**RE: Responses to March 12, 2018 EPD Comments
Thermo King Corporation - Louisville, Jefferson County, Georgia
HSI Site No. 10702 Tax Parcel 0090-024
Wood Project 6122-09-0322**

Response to March 12, 2018 EPD Comments
Thermo King Corporation - Louisville, Jefferson County, Georgia
HSI Site No. 10702 Tax Parcel 0090-024
Wood Project 6122-09-0322

WORK PLAN FOR SOIL INVESTIGATION AT THE MAIN BUILDING TO BETTER DEFINE THE TYPE 5 RISK REDUCTION STANDARDS AREA

FIGURE 1

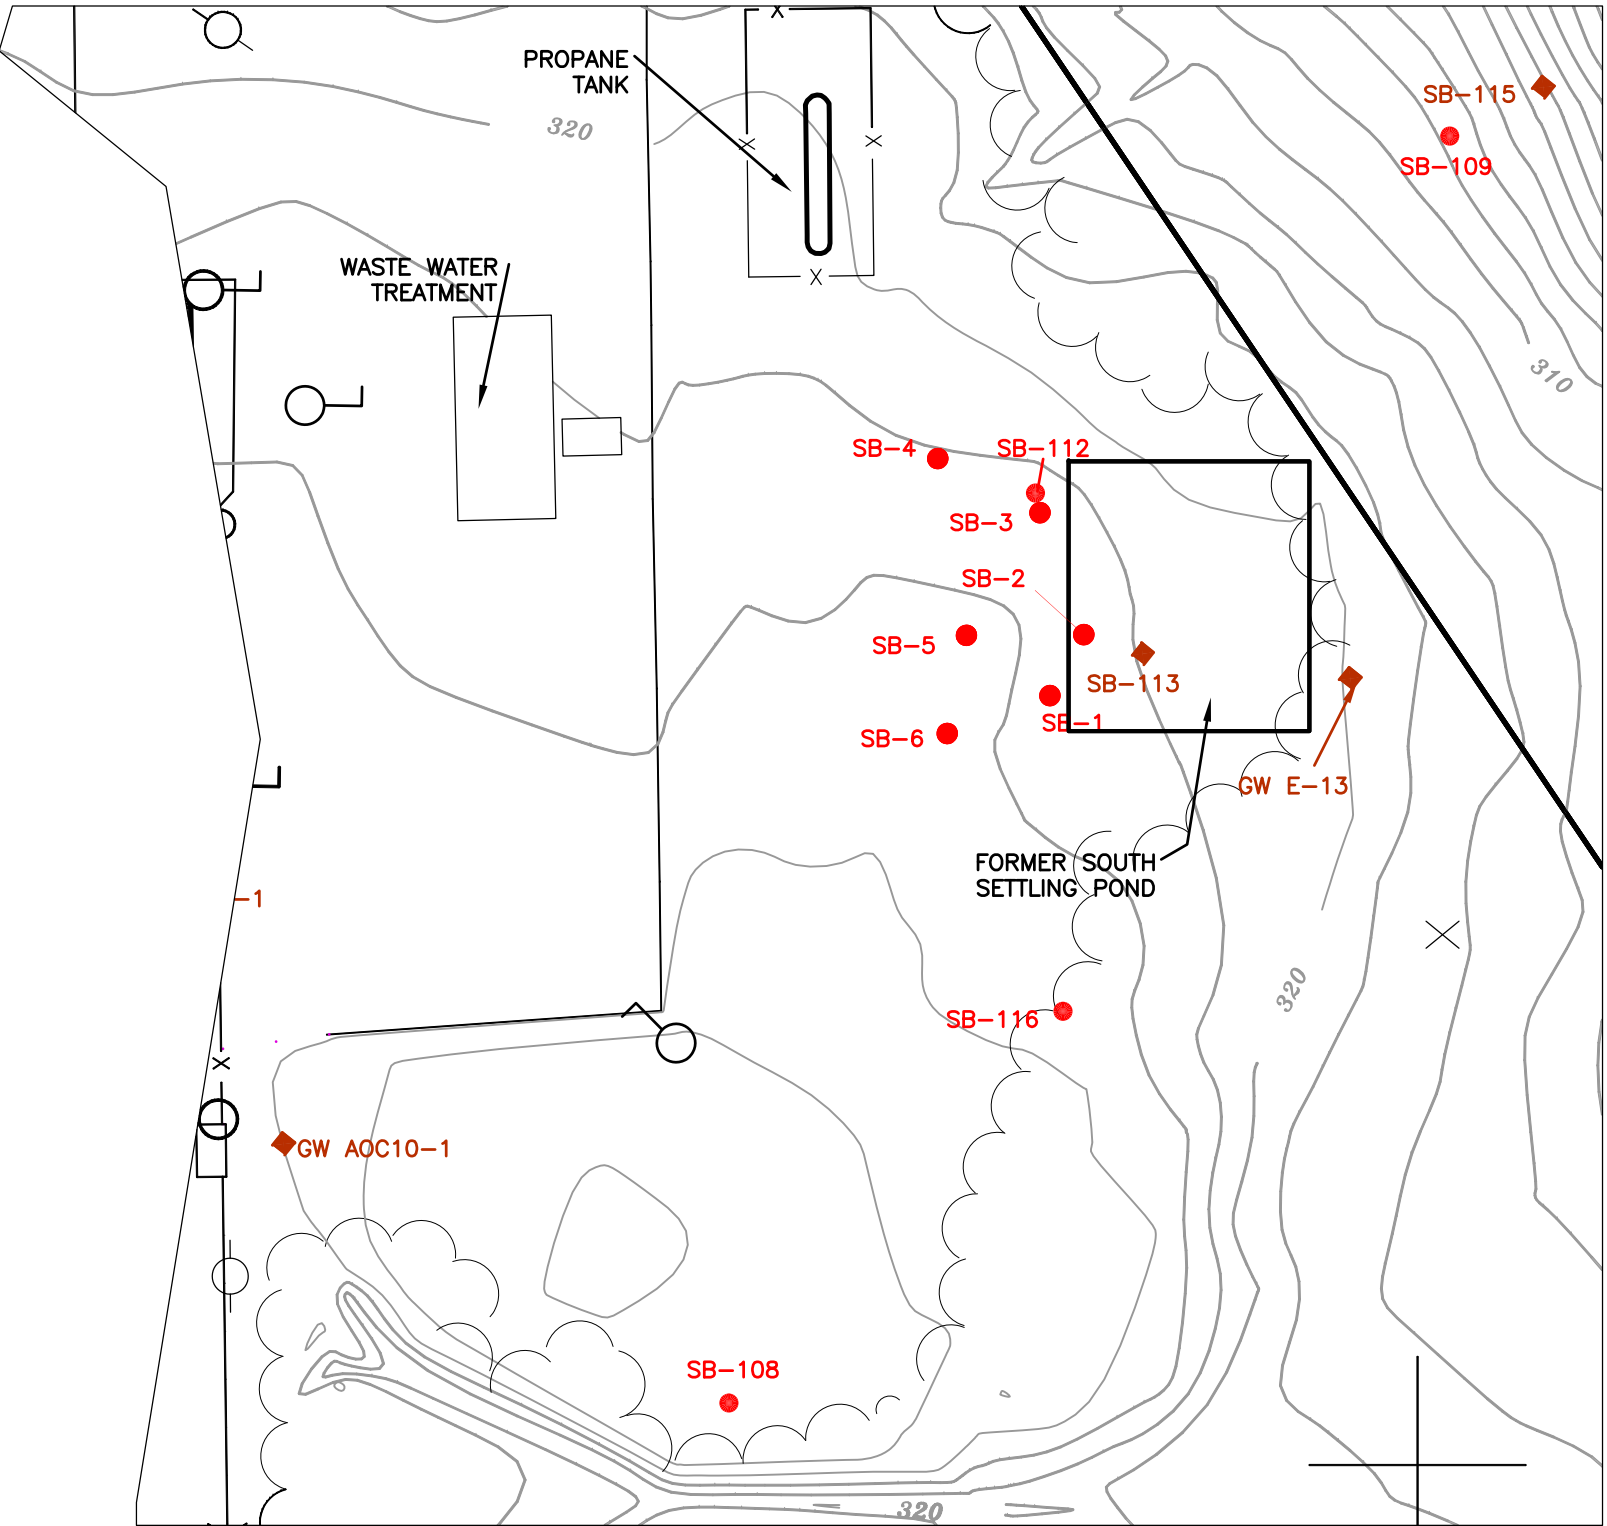
a. The current proposed area of soil investigation does not address the detection of trichloroethene (TCE) in soil at concentrations exceeding the Type 1 through 4 RRS near the former south settling pond, at boring SB-112 [18-19 ft below ground surface (bgs)]. In addition, there are insufficient analytical results for 1,4-dioxane to verify compliance with applicable RRS in the same area. This is because: 1) the reported laboratory "detection limit" for 1,4-dioxane in the referenced SB-112 soil sample is greater than the applicable Type 1 through 4 RRS, and 2) many soil samples collected near the SB-112 location were not analyzed for 1,4-dioxane.

The former south settling pond ("pond") and the locations of borings drilled in this area to investigate the presence of constituents in surface and subsurface soils in the former pond area are shown on Figure 1. The pond was field-located by referencing its location to site features shown on a 1981 aerial photograph. The pond location as shown on Figure 1 is considered to be approximate because the pond was abandoned in 1983 and had been filled/covered by the time environmental investigations began in 2000. Documentation of pond construction details, pond closure, or the specific contents of the wastewater piped to the pond are unavailable. However, it is noted that the pond was in operation from 1970 until 1983 and that the primary solvent used at the site during this period was TCE. In 1988, five years after the pond was closed, the facility switched from TCE being the primary degreasing solvent to using TCA and its stabilizer 1,4-dioxane.

Ten borings were drilled in 2000 and 2003 as a part of investigations conducted in the vicinity of the pond. These were GW-E-13, SB-1 through SB-6, and SB-112, SB-113, and SB-116 (see Figure 1). Sixteen soil samples were collected at depths ranging from 0 – 2 feet to 40 – 42 feet. Five of the samples were collected from depths greater than 10 feet. The soils were analyzed for volatile organic compounds by 8260B; 1,4-dioxane was not reported as a site constituent until 2003.

In only one of the 16 soil samples (collected from SB-112 at a depth of 18-19 feet) was the Type 1 RRS of a constituent exceeded (560 µg/kg versus 500 µg/kg). The TCE concentration did comply with the Type 2 RRS (1800 µg/kg). The next highest TCE concentration was 130 (estimated) µg/kg, detected in boring SB-1. The median TCE concentration was 16 µg/kg. Considering the number and relatively close proximity of other pond area borings to SB-112 (Figure 1), it is considered unlikely that TCE is more than sporadically present in the former pond area at concentrations exceeding its Type 1 through Type 4 RRS and that the SB-112 result is atypical of the area. As such, it is Thermo King's opinion that since: 1) the presence of TCE at concentrations exceeding its Type 1 through 4 RRS is atypical of soils in the former pond area and 2) the facility's Environmental Covenant requires that a risk assessment must be performed at the site prior to conducting soil disturbing activities, neither additional investigations in this area nor construction of an engineering control are necessary to provide for protection of human health or the environment.

1,4-Dioxane was reported as being non-detect in the analyses of the 10 samples collected from the former pond area at detection limits ranging from <200 to <26,000 µg/kg. 1,4-Dioxane in only one sample (the 18-19-foot sample from boring SB-112) was reported as being non-detect at a concentration exceeding the Type 1 through Type 4 RRS (<26,000 µg/kg). 1,4-Dioxane was not analyzed in the six samples (SB-1 through SB-6) collected in early 2000, before site studies included the analysis for 1,4-dioxane. No constituents were detected in these six samples at concentrations exceeding Type 1 through Type 4 RRS. Considering that 1,4-dioxane is a stabilizer in TCA and that TCA was not used as a solvent cleaner at the site until 1988, five years after south pond operations were terminated, it is Thermo King's opinion that the absence of TCA and 1,4-dioxane in samples collected from the pond area is consistent with the history of their use at the site and that additional sampling for 1,4-dioxane is not warranted.

Figure A-1	Proposed Soil Boring Locations
Figure A-2	Estimated Schedule

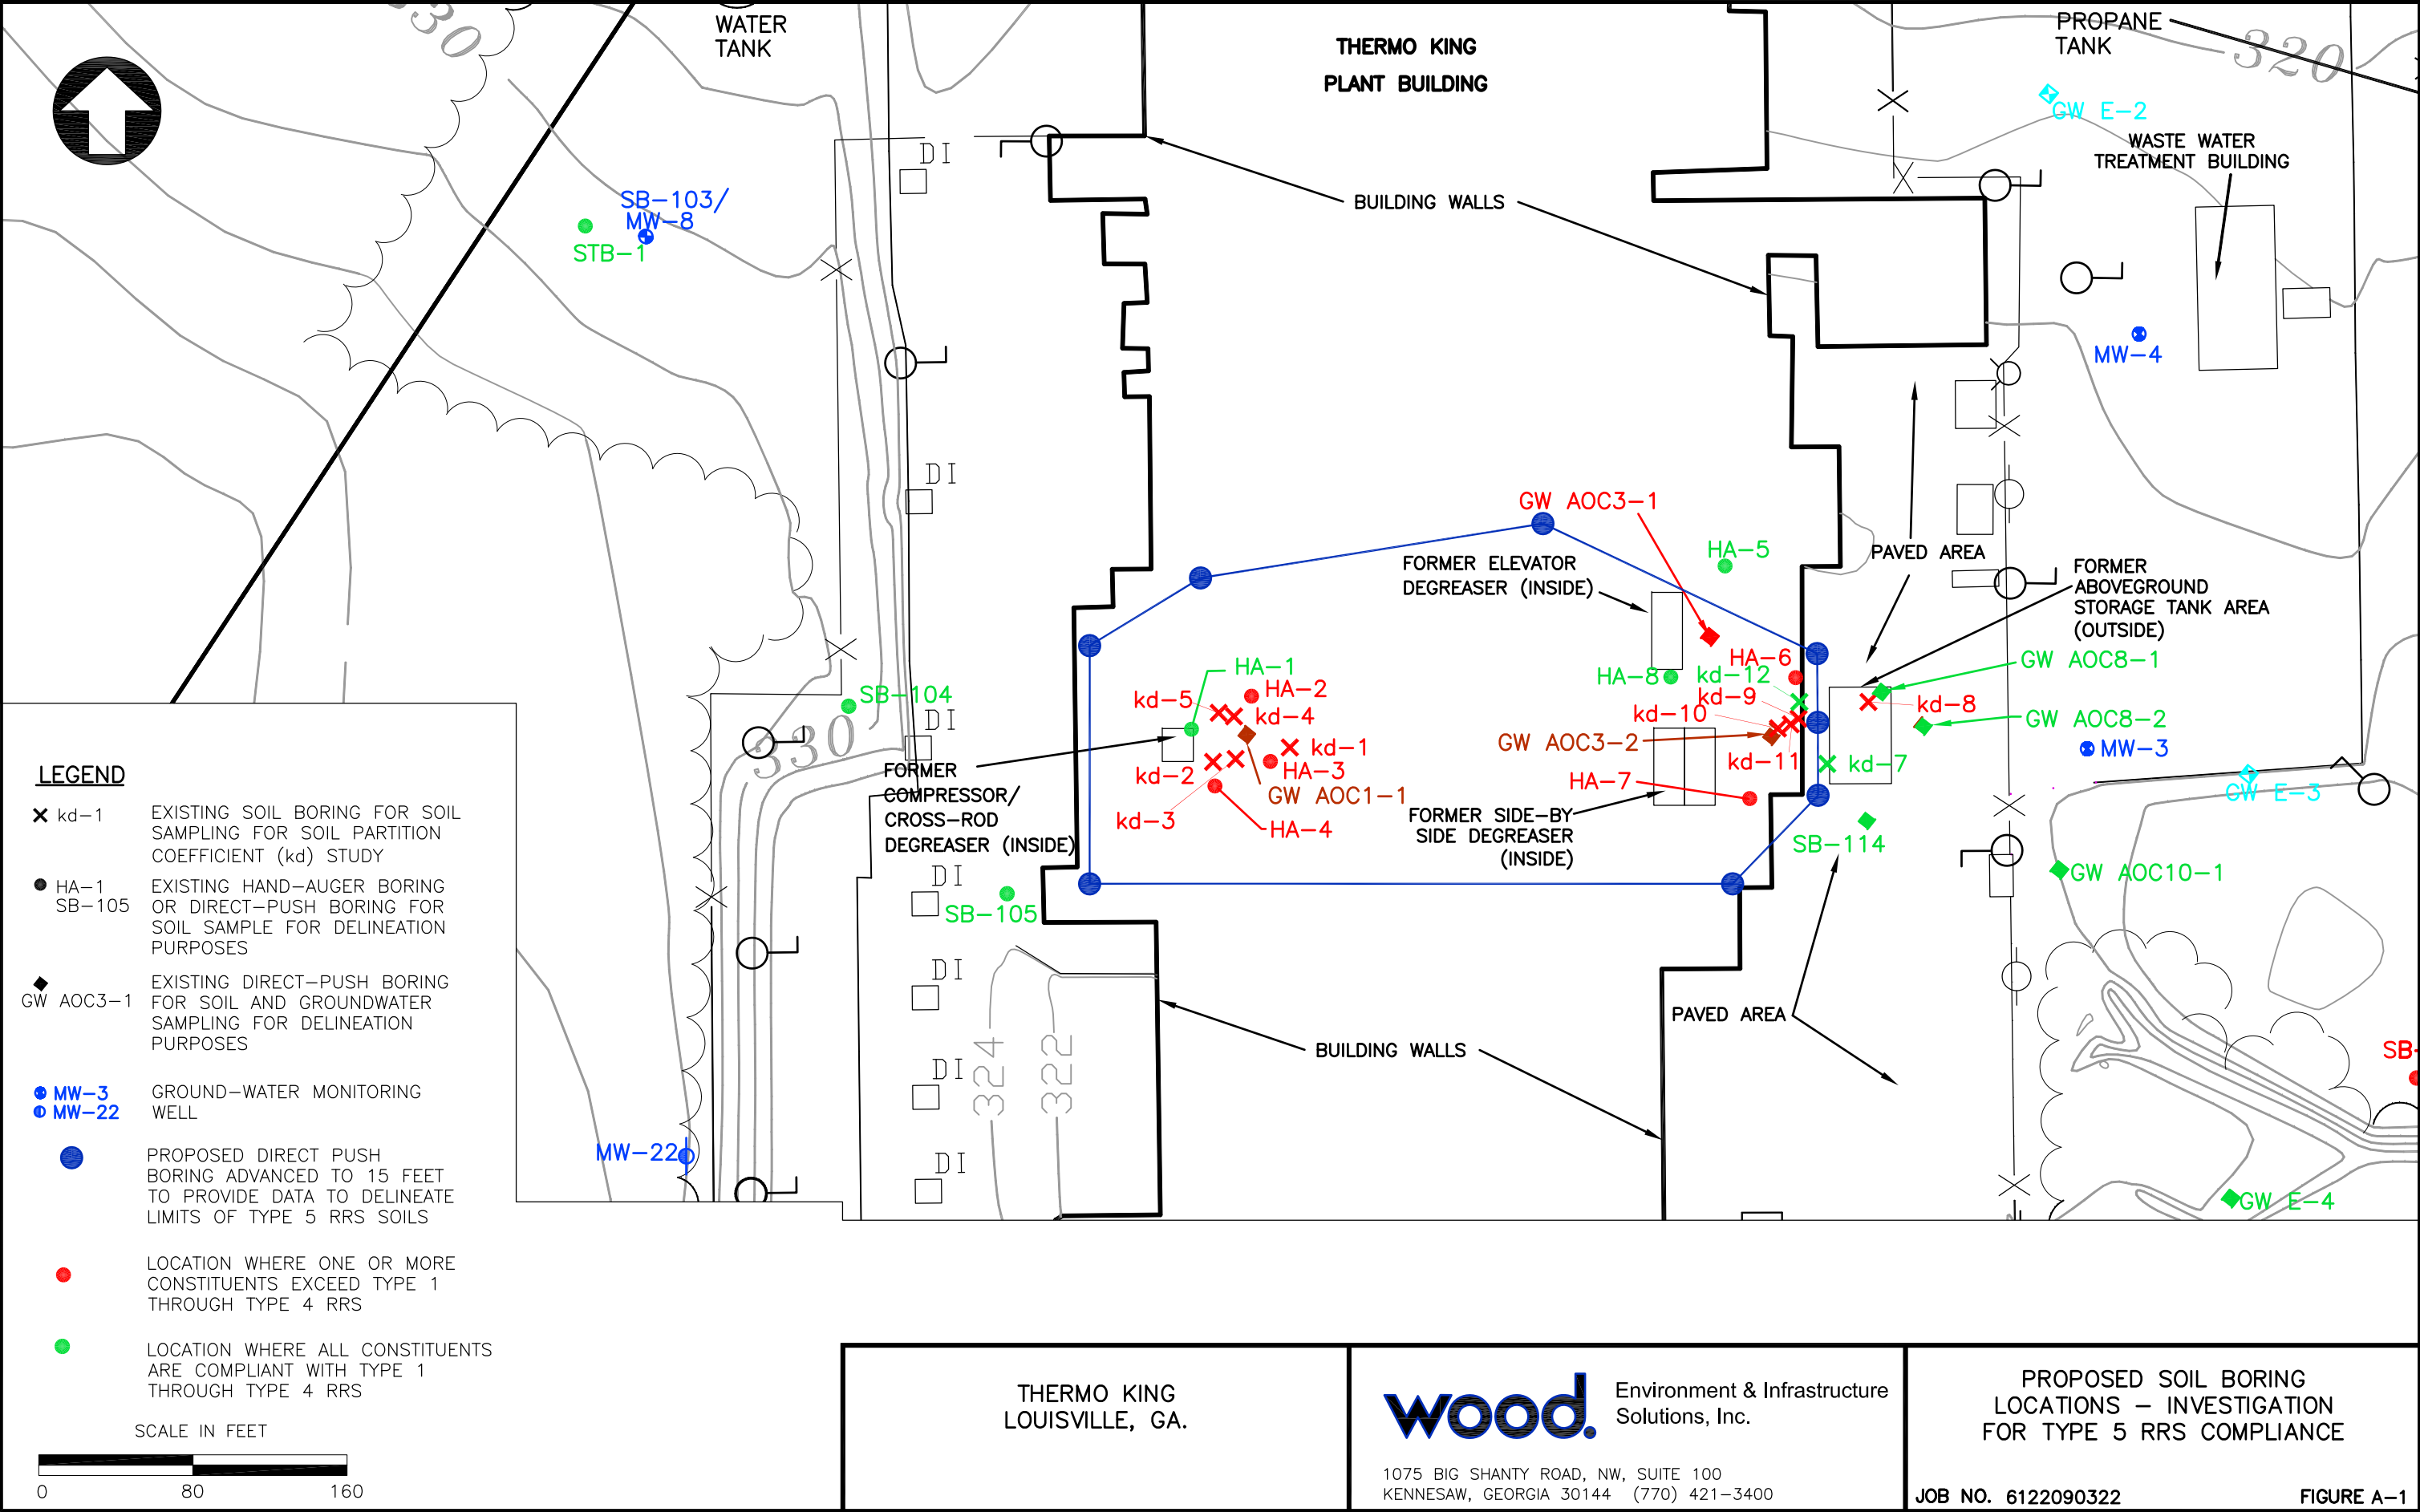
Comment #2: EPD Comment #6: Wood's response to this EPD Comment, "proposes to conduct additional soil sampling inside the building to the north, west, and south of the former degreaser locations, areas where soil constituent concentrations exceed Type 1 to 4 RRSs." EPD concurs with Ingersoll-Rand's decision to conduct an additional soil investigation. However:

b. A milestone schedule for conducting the proposed investigation was not provided in the responses to EPD comments. Based on a conversation between Ms. Carolyn Daniels of EPD and Ms. Rhonda Quinn of Wood on March 6, 2018, it is EPD's understanding that Ingersoll-Rand and Wood are awaiting EPD's comments regarding the subject submittals before proceeding with the proposed soil investigation. Please contact Ms. Carolyn L. Daniels, P.G. of my office at your earliest convenience to arrange a time for a face-to-face meeting or conference call for this purpose. A short written work-plan with large scale figures showing close up views of the areas to be investigated should be submitted to EPD via email at least one week before the proposed meeting or conference call. The figures should clearly identify:

- Existing site features (building walls, extent of concrete building slabs and /or asphalt/concrete pavement, etc.),
 - Potential source locations such as former degreaser locations, settling ponds, etc.,

- Historical soil sampling locations with analytical results for 1,4-dioxane and TCE posted immediately adjacent to their associated sampling locations, and

- Proposed soil sampling locations.
- i. Please note when selecting soil sampling locations for the proposed investigation: Non-detections of 1,4-dioxane and/or TCE in soil that are based on laboratory reporting limits greater than the applicable Type 1 through 4 RRS are not acceptable for determining the presence of the referenced substances, nor may they be used to delineate the extent of the areas where compliance with Type 5 RRS is to be maintained through the use of engineering controls. EPD noted that the following soil samples, based on a preliminary review of Figures 2.3-1 A and -1 B submitted with your responses to EPD comments, had elevated laboratory reporting limits greater than applicable Type 1-4 RRSs:

Previous sampling locations shown on Figure A-1 where constituents were detected at concentrations exceeding Types 1 through Type 4 RRS, or were reported as being non-detect at elevated detection limits, are designated in red. Conversely, sampling locations where constituents concentrations met the Type 1 through Type 4 RRS or were reported as being non-detect with detection limits meeting the Type 1 through 4 RRS are in green. The proposed sampling locations were elected to obtain data to reduce the size of the Type 5 RRS soil footprint. Prior to implementing new borings, the previous soil borings locations will be identified and marked. A surveyor will be used to locate the previous boring locations using previous surveyed coordinates.

Based on a review of the existing soils data, Thermo King proposes to drill and sample 8 soil borings, at the locations shown on Figure A-1. Five of the eight borings will be inside of the building. These five borings will be used to better define and reduce the limits the Type 5 RRS area to the north, west, and south of the degreaser areas.

Previous soil samples (Kd-9 to Kd-11) were collected adjacent to the interior east building wall and had VOC concentrations greater than the Types 1 through 4 RRS. The current delineation of the Type 5 RRS soils area extends about 65 feet outside of the building on the east side. Three borings will be drilled and sampled on the east exterior side of the building (Figure A-1) to collect data to allow the eastern limits of the Type 5 RRS to be moved to a point adjacent to the exterior of the building wall.
